Additional information for the KIT-F9FI-DU8 installation manual

Applies to 2024–present Fiat Ducato vehicles

8. CAN cable colors >2024
Blue = CAN High
White = CAN Low

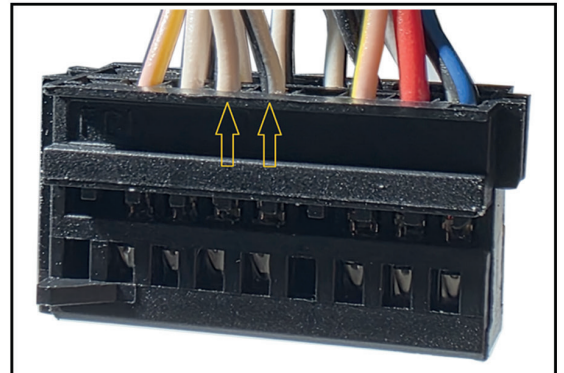
There has been a change in the CAN communication wire colors. Refer to page 4 in the installation manual for KIT-F9FI-DU8. See picture below.

8. CAN cable colors <2024
White = CAN High
White/black = CAN Low

*The pin location of the cables is identical for both old and new color coding.
Please follow the installation steps in the KIT-F9FI-DU8 manual and note that only the wire colors differ.*

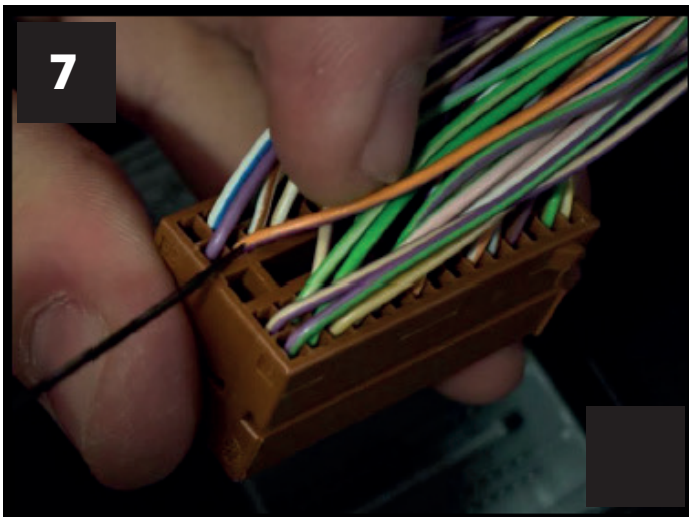
In some vehicles, the grey connector in the center console may be missing. If this connector is not present, connect the LIN communication wire directly to the body computer.

Remove the fuse holder cover and the bottom cover, unscrewing the 5 screws

The LIN wire is the orange/violet wire in the second position of the second row.

If the appropriate tooling or the pre-terminated connector and wiring are not available, solder and insulate an extension wire to connect the LIN bus to the adapter's white wire in the grey LIN connector.
